Subject: Plant Organization

PALISADES PLANT

AMENDMENT TO PROVISIONAL OPERATING LICENSE

Amendment No. 46
License No. DPR-20

Figure 6.2-2

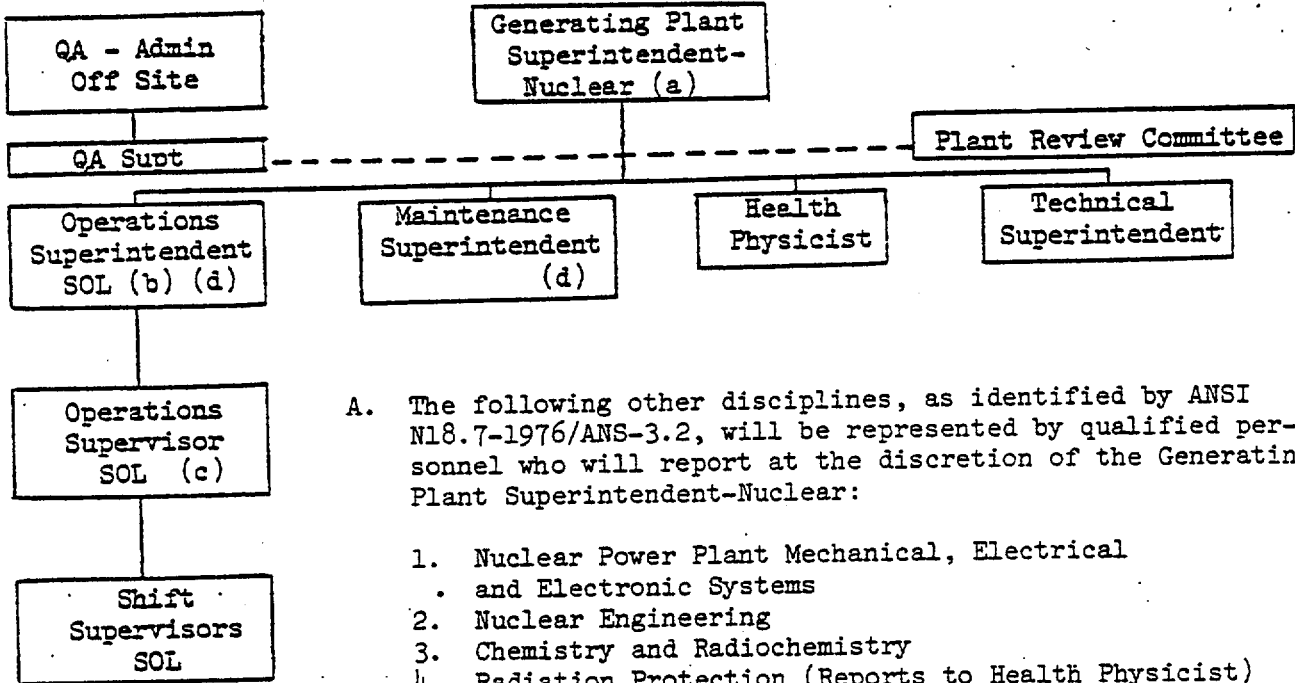
The plant organization chart, Figure 6.2-2 now has five line supervisors reporting directly to the Generating Plant Superintendent-Nuclear. These are the Operators Superintendent, Maintenance Superintendent, Administrative Supervisor, Health Physicist, and Technical Superintendent. The revision would delete the Administrative Supervisor and functions reporting to this supervisor from the Technical Specifications. These functions include the Stockman, Office Personnel, and the Security Force. The position of Administrative Supervisor, Stockman, and Office Personnel are not directly related to plant safety. Therefore, we have no requirement that such positions exist and their deletion from the Technical Specifications would have no effect on plant safety. The proposed revision would require that the security force will be supervised as described in the Plant Security Plan. This change would be consistent with current NRC practice which places security force requirements in the Security Plan rather than in the Technical Specifications. This change in manner of specifying requirements would have no adverse effect on the security plan.

The revision would also allow the positions of Operators Superintendent and Maintenance Superintendent to be combined under one individual. In addition, it would delete the organizational relationship and specification of two of the positions now reporting to the Operators Superintendent and all the positions reporting to the Maintenance Superintendent, Health Physicist, and Technical Superintendent. Instead, the revised specification would specify the required safety related discipline which must be represented by the staff and would require that the personnel supervising these disciplines report to the Generating Plant Superintendent-Nuclear or to an individual who reports directly to the Generating Plant Superintendent-Nuclear. The change would therefore provide flexibility in the organization without affecting the number and type of technical disciplines or the reporting level of the supervisors of these disciplines. In the event the positions of Superintendent Operators and Maintenance Superintendent are combined in accordance with Figure 6.2-2, the individual holding both positions serves as a single voting member of the Plant Review Committee (Specification 6.5.1.2).

- (a) Responsible for the Plant Fire Protection Program
- (b) The Operations Superintendent need not hold an SOL provided he meets the other requirements of 6.3.1 of these Specifications and the position of "Operations Supervisor" is filled. Under these conditions, the Operations Supervisor shall be responsible for directing the activities of licensed operators.
- (c) This position need not be filled if the Operations Superintendent holds an SOL. However, when the Operations Supervisor position is filled, that individual shall hold an SOL.
- (d) The Operations and Maintenance Superintendents' positions may be combined under one individual. When this occurs, the operations supervisor position will be filled.
